KEADBY 3 CARBON CAPTURE POWER STATION

Document Ref: 10.6

The Keadby 3 (Carbon Capture Equipped Gas Fired Generating Station) Order

Proposed Development Changes: Environmental Statement (ES) Addendum Non-Technical Summary

Figure NTS4: Order Limit Changes

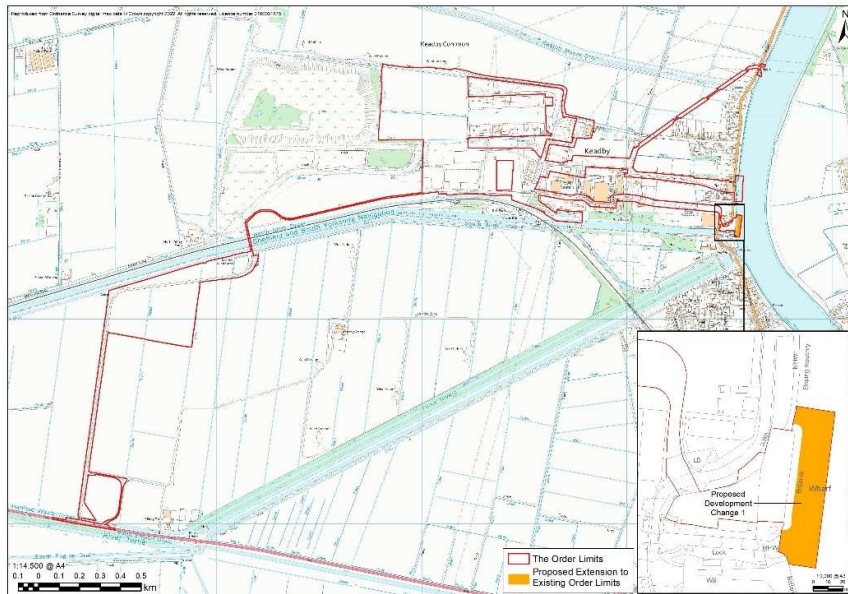
3.2.5 The Proposed Development Change that affects the Order Limits is Proposed Development Change 1: addition of a section of river bed to be used by moored vessels in the Waterborne Transport Off-loading Area.

Figure NTS6: Indicative Proposed PCC Site Layout Single Absorber

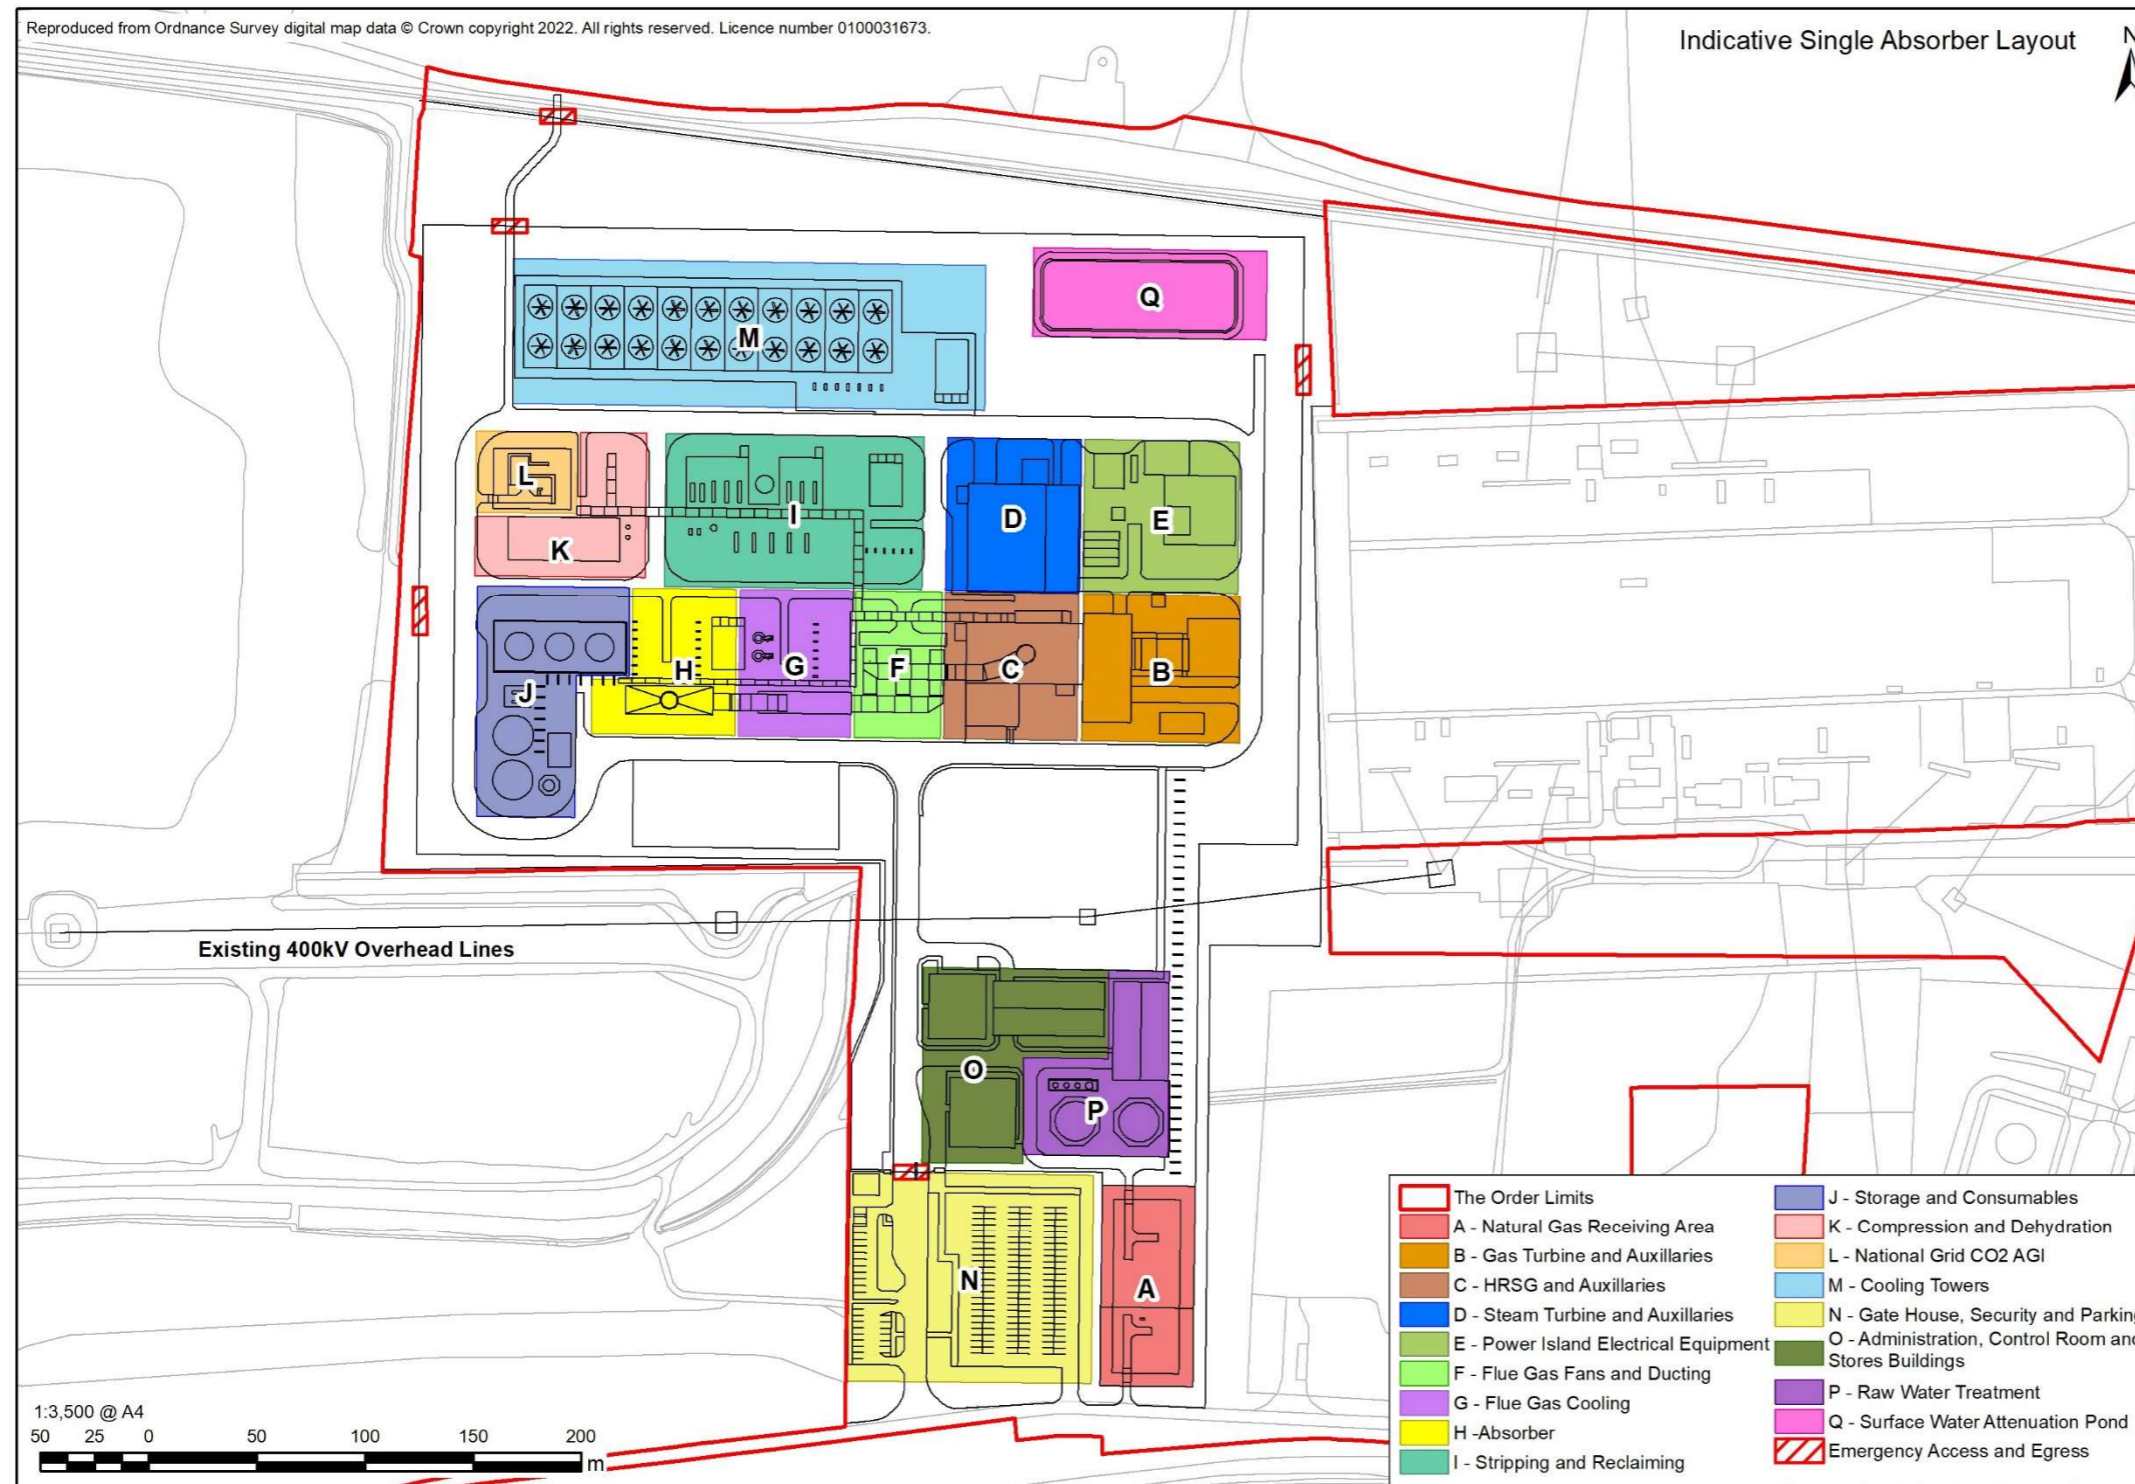
4.2.4 **Figures NTS6 and NTS7** show an indicative layout of the Proposed PCC Site. **Figure NTS6** shows the indicative layout of the Proposed PCC Site with a single absorber installed. **Figure NTS7** shows the indicative layout of the Proposed PCC Site based on the twin absorber option. The CCGT and CCP including absorber stack(s) would still be located within the defined **Work Areas 1A and 1C (Application Document Ref. 4.3)** i.e. within the Main Site on the northern part of the Proposed PCC Site.

Figure NTS7: Indicative Proposed PCC Site Layout Twin Absorber

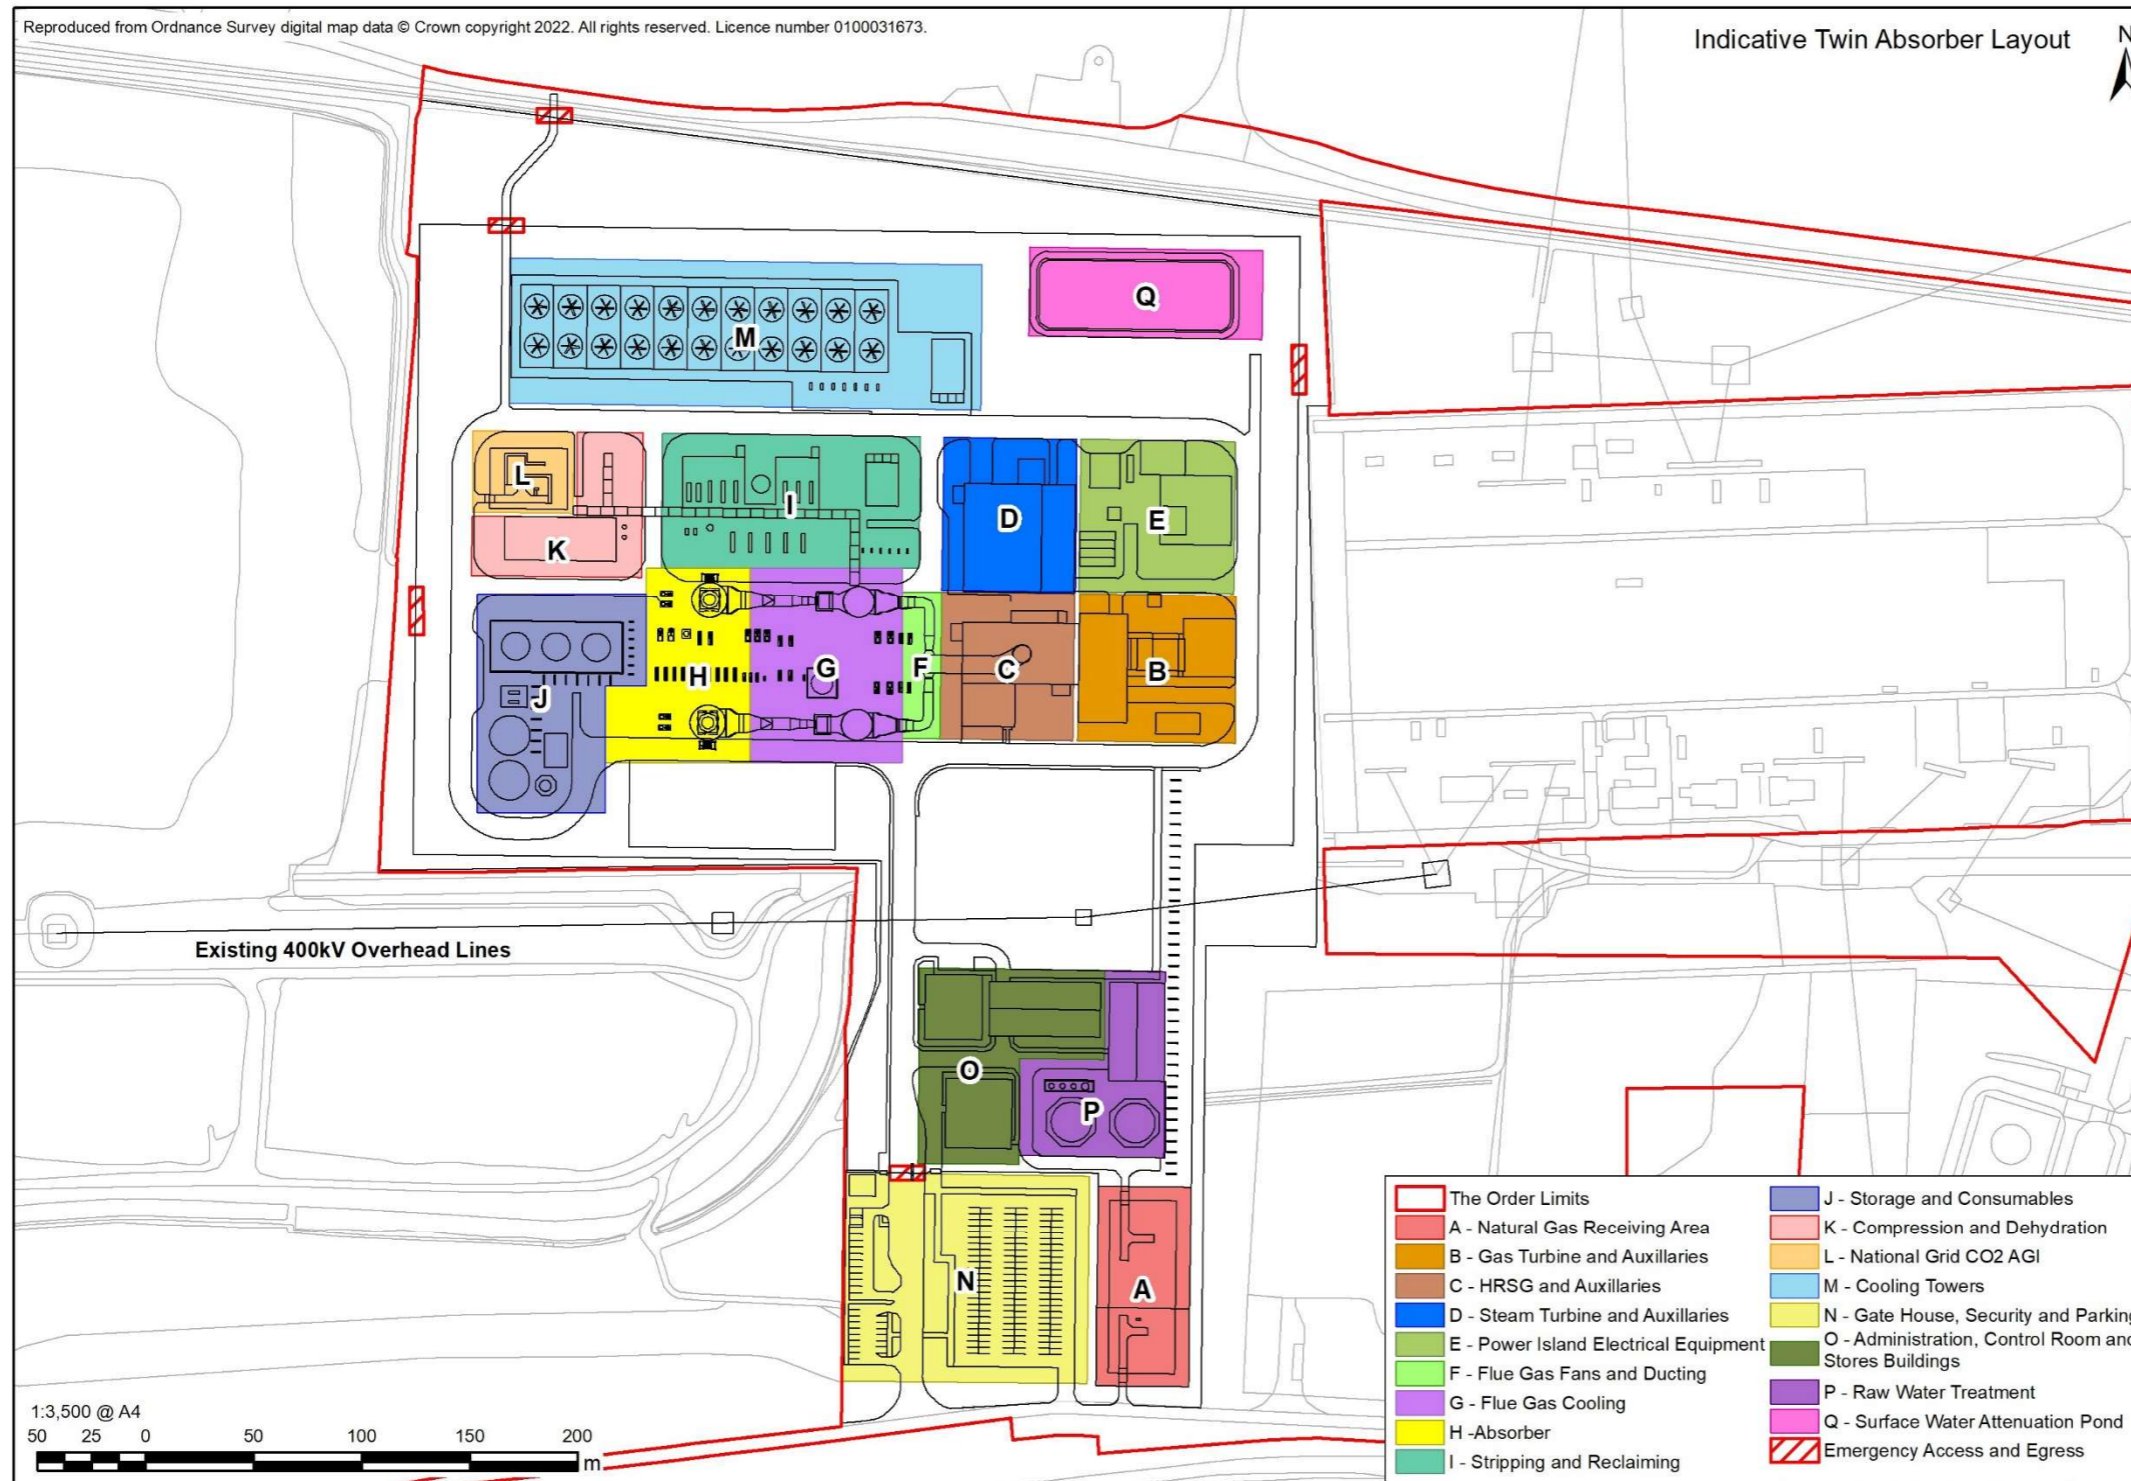
- **Change 3: Increase to the maximum parameters (height) for up to two absorbers/ stacks.** Ongoing engagement with design contractors has identified that in the event that two absorbers are required for the removal of CO₂ from flue gases within the CCP (Work No. 1C), the twin absorber units and stacks may extend to a maximum height of up to 80m above ground level (AGL) for the absorber towers and an additional up to 15.5m in height for the stacks i.e. up to 95.5m AGL in total, which equates to a maximum of 98.3m Above Ordnance Datum (AOD) for each absorber and associated stack. These maximum dimensions – established through ongoing design development - are approximately 20m higher than those previously assessed for the twin absorber option in the submitted ES and presented as a parameter in the draft DCO [**APP-005**], albeit they are still lower than the maximum height assessed for the single absorber option.

Figure NTS8: Abnormal Indivisible Load Route from Wharf

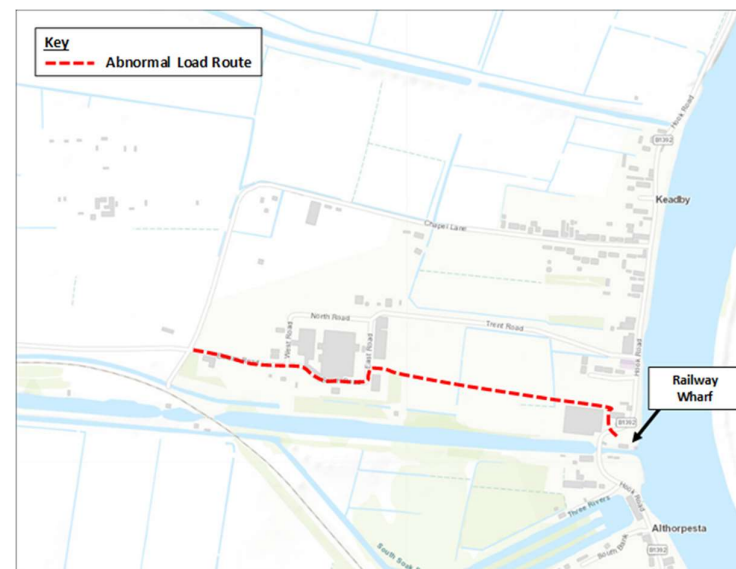
- For AIL arriving at the Waterborne Transport Offloading Area, the Applicant proposes to use the route solely through Keadby Power Station, although an alternative to this route was previously considered as part of the change request application submitted at Deadline 5 in order to minimise potential risks associated with

abnormal loads traversing the operational Keadby Power Station site. The Applicant has therefore considered an alternative northern extension of the Additional AIL Route.
